NEBRASKA ARMY NATIONAL GUARD O'NEILL RC FRONT ENTRY AND LATRINE PROJECT

PROJECT NO. 31030149

A D D E N D U M N O . 1

1 DEMOLITION PLAN

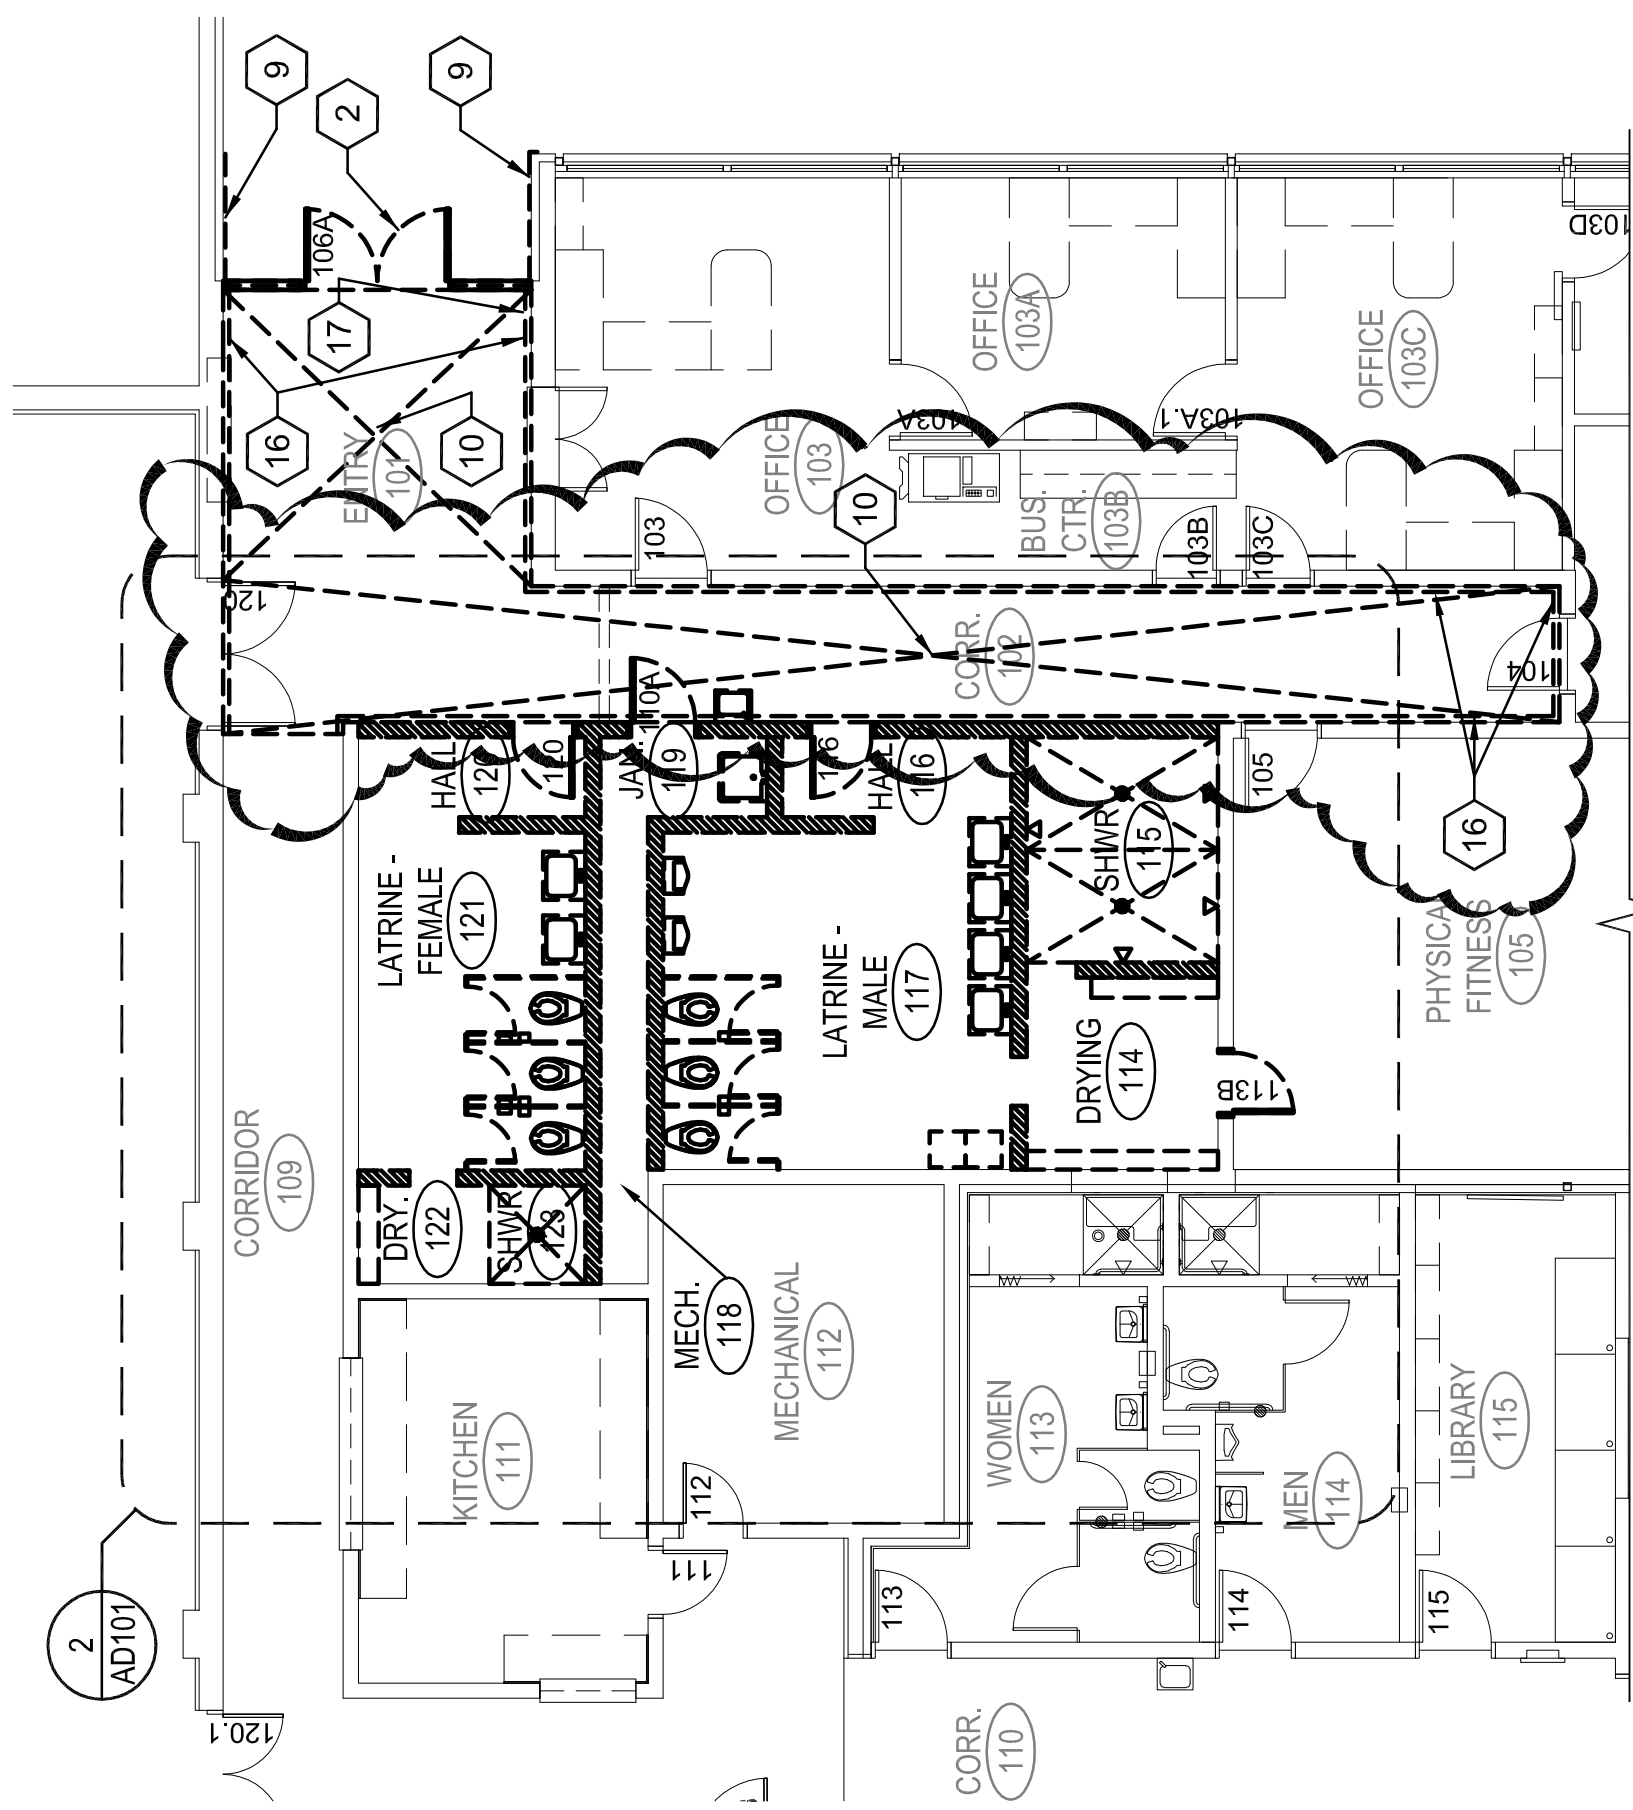
ADD 1-3 Sheet AD101
Refer to Demolition Plan 1/AD101, See attachment AD 1-1 for additional extent of asbestos floor tile removal and base removal.

-  → REMOVE ASBESTOS CONTAINING VINYL FLOOR TILE AT "X" COMPLETE.
-  → REMOVE ASBESTOS CONTAINING FLOOR TILE TO THE TILE JOINT WEST OF EXISTING DOOR FRAME 120.
-  → REMOVE BASE SHOWN DASHED.

ENLARGED FLOOR PLAN
SCALE: 1/4" = 1'-0"

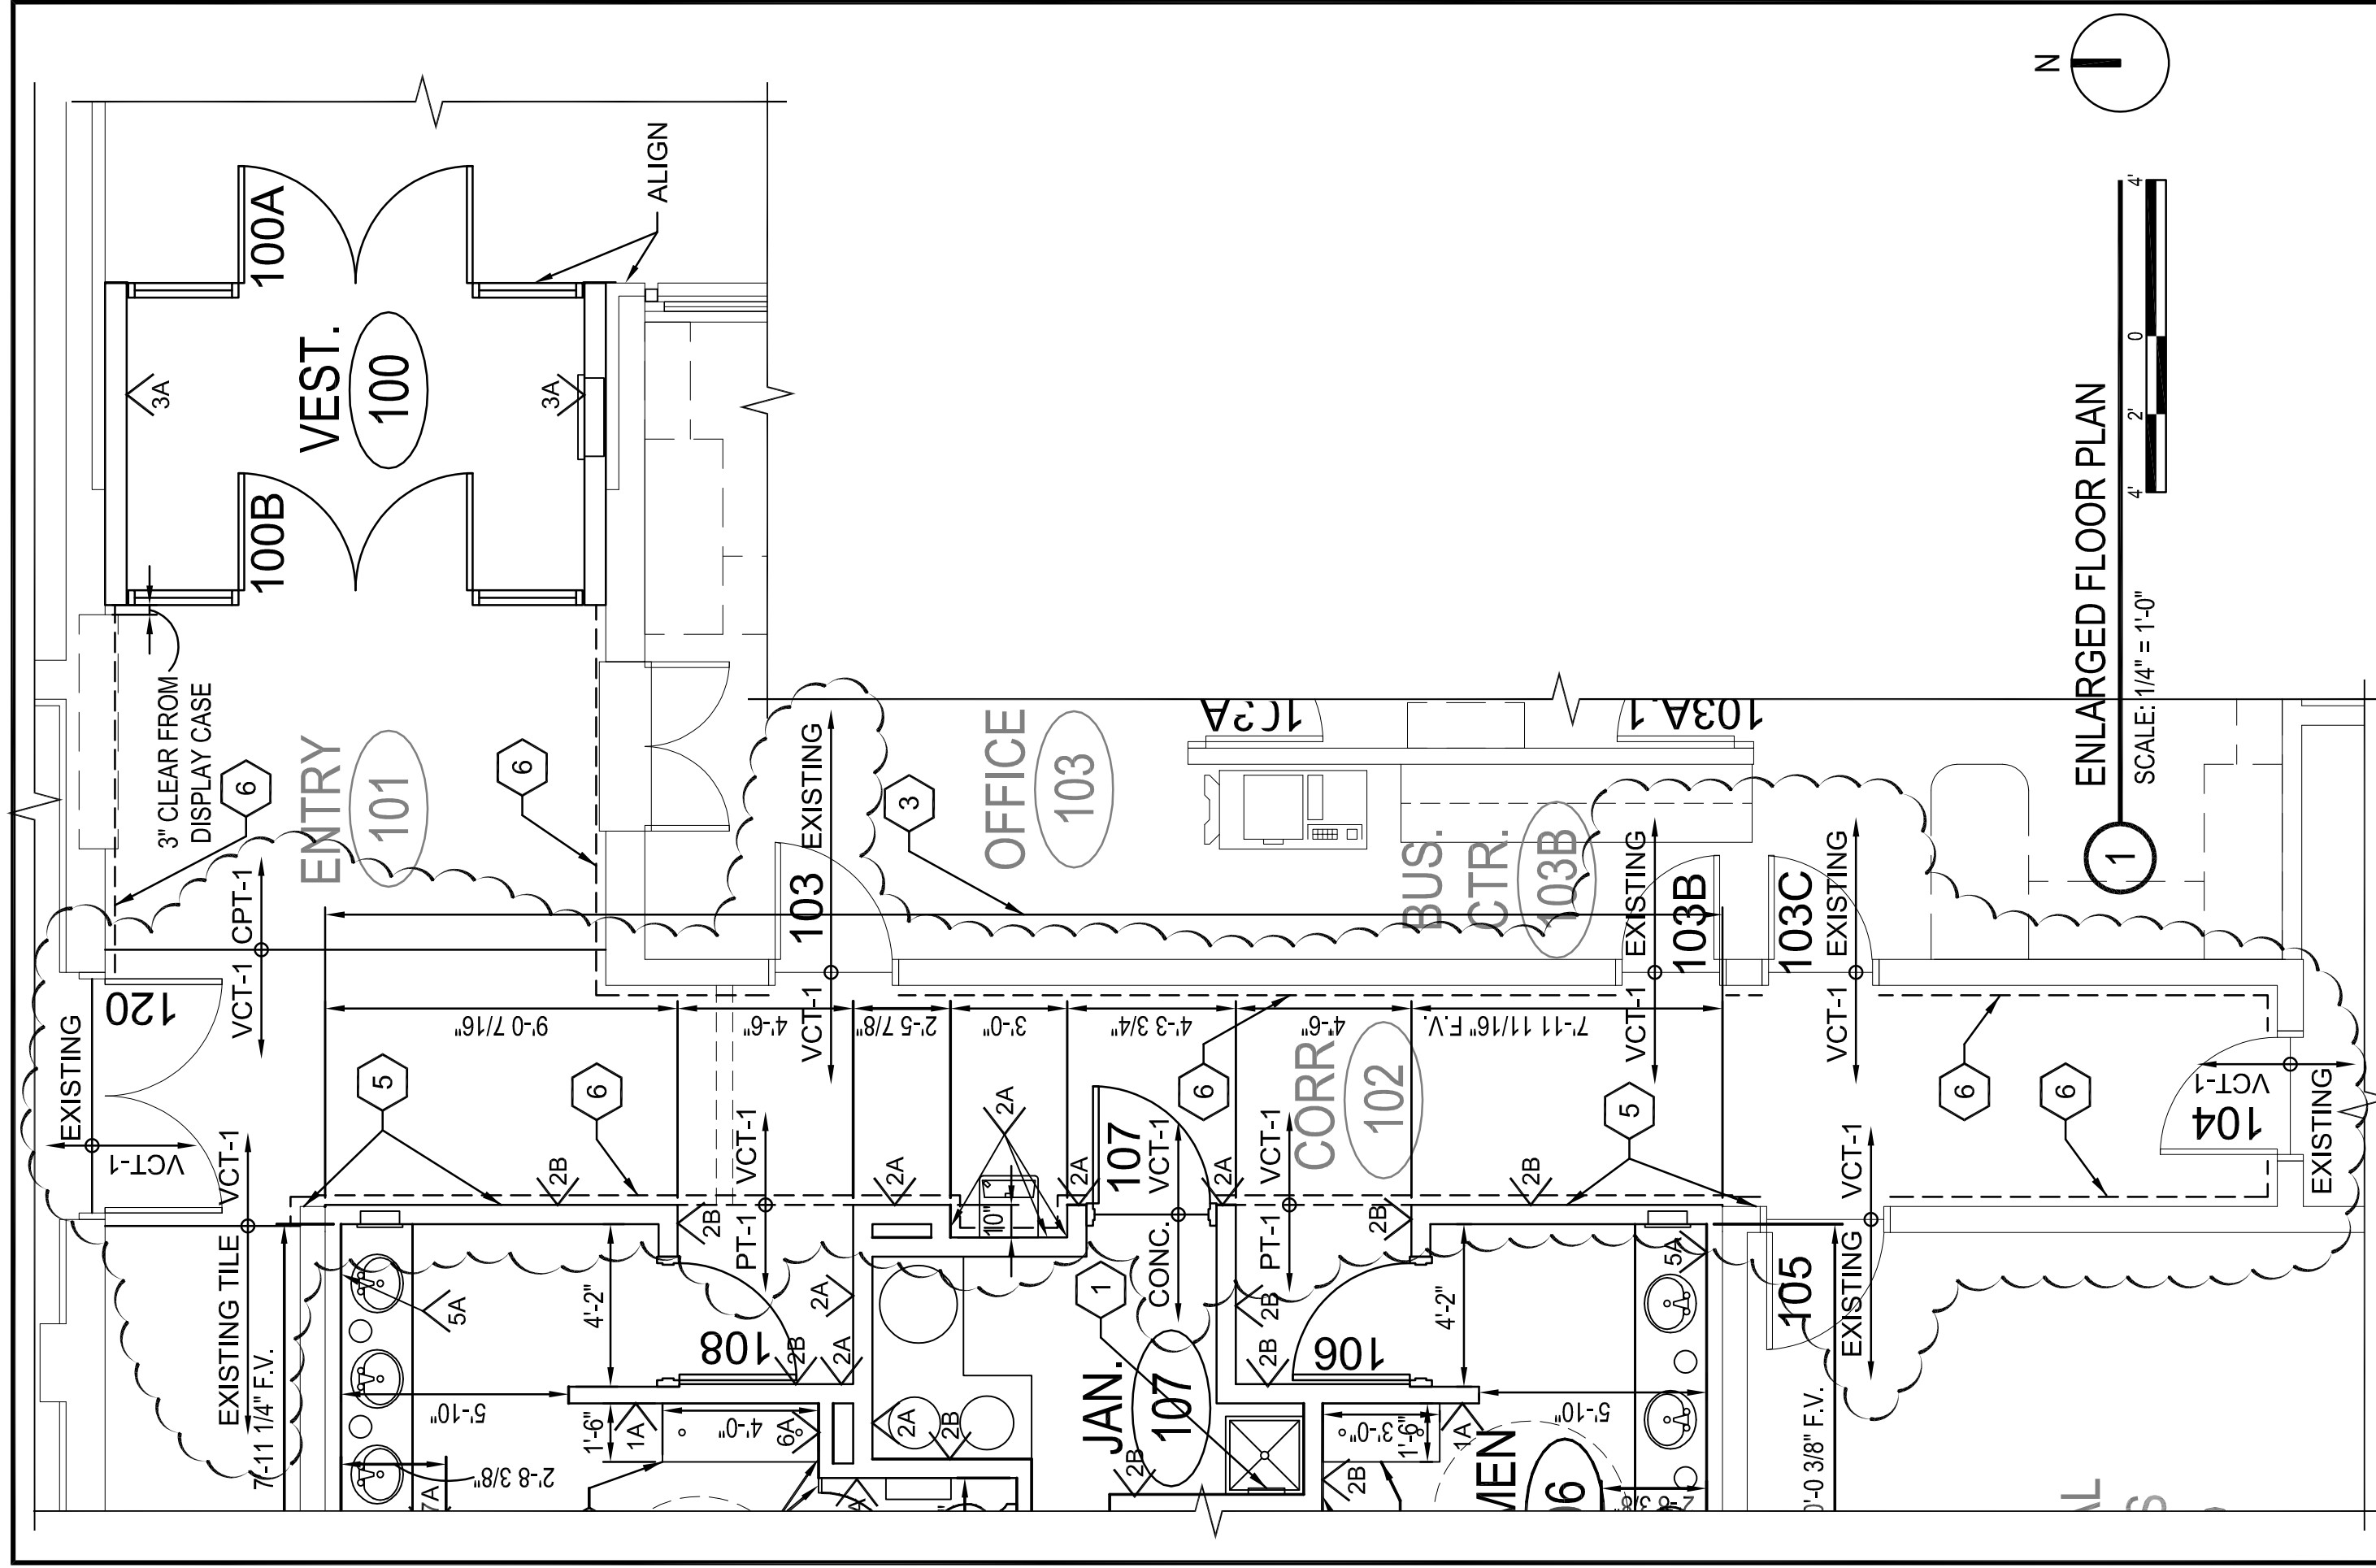
ADD 1-4 Sheet A-401
Refer to Enlarged Floor Plan 1/A-401, See attachment AD 1-2 for additional extent of new flooring and base replacement.
